UNITED STATES DEPARTMENT OF THE INTERIOR BUREAU OF LAND MANAGEMENT

SUNDRY NOTICES AND REPORTS ON WELLS 5. Lease Serial No. NMNM27506

Delaware Basin Changes to APD for Federal Well

Summary of Changes to APD Submission

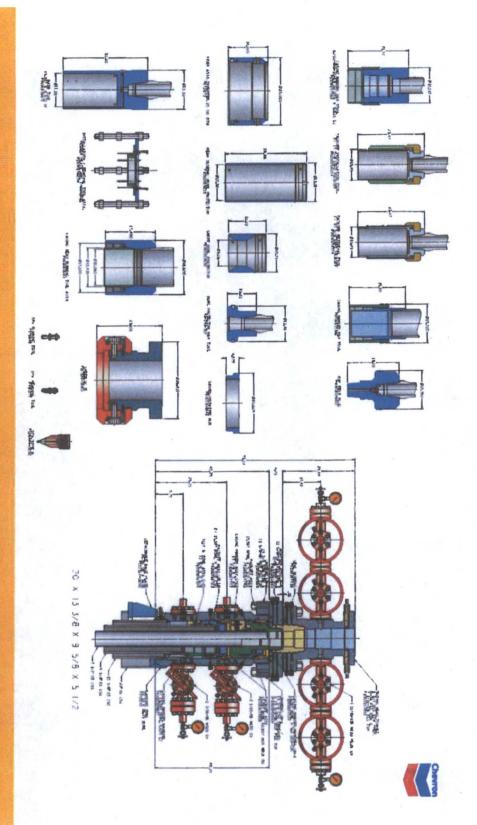
Chevron respectfully request the ability to batch drill in the SALADO DRAW (18-19) 26 33 PAD (6TH), AND USE A FMC UH2 MULTIBOWL WH. The summary provided below is a brief description of the main operational sequences for drilling and casing of the five wells listed above.

- 1. Drill 17-1/2" surface hole with fresh water to planned casing set depth with 10' rat hole.
- 2. Run casing as stated by approved APD, land out wellhead, and cement.
- 3. Dress out 13-5/8" 5M SH-2 wellhead and install/secure with temporary abandonment cap, and a pressure gauge will be installed. Reference image below.
- Skid to next well according to below "Drill Order"

As Defined in APD:	As Planned on Well:		
Variance to batch drill not requested.	Chevron respectfully request the ability to batch drill in the SALADO DRAW (18-19) 26 33 PAD (6 TH). The summary provided is a brief description of the main operational sequences for drilling and casing the four wells listed.		
Section 3 – Chevron Request a variance to use a GE/Vetco SH-2 Multibowl Well Head	Chevron Request a variance to use a FMC UH2 Multibowl Well Head

The original COAs for each well still stand with the following drilling modifications:

- Once the Rig is on location, it will drill the above mentioned wells in conjunction using batch drilling.
- BOP/BOPE test to be conducted per Onshore Oil and Gas Order No. 2 as soon as
 the Rig is rigged up on well and each time the BOP/BOPE is nippled up. CIT for
 all casing shall be performed and results recorded on subsequent sundry.

- 2. Operator has proposed a multi-bowl wellhead assembly. This assembly will only be tested when installed on the surface casing. Minimum working pressure of the blowout preventer (BOP) and related equipment (BOPE) required for drilling below the surface casing shoe shall be 5000 psi.

- a. Wellhead shall be installed by manufacturer's representatives, submit documentation with subsequent sundry.
 - b. If the welding is performed by a third party, the manufacturer's representative shall monitor the temperature to verify that it does not exceed the maximum temperature of the seal.

- c. Manufacturer representative shall install the test plug for the initial BOP test.
 - d. Operator shall perform the intermediate casing(s) integrity test to 70% of the casing burst. This will test the multi-bowl seals.

- e. If the cement does not circulate and one inch operations would have been possible with a standard wellhead, the well head shall be cut off, cementing operations performed and another wellhead installed.
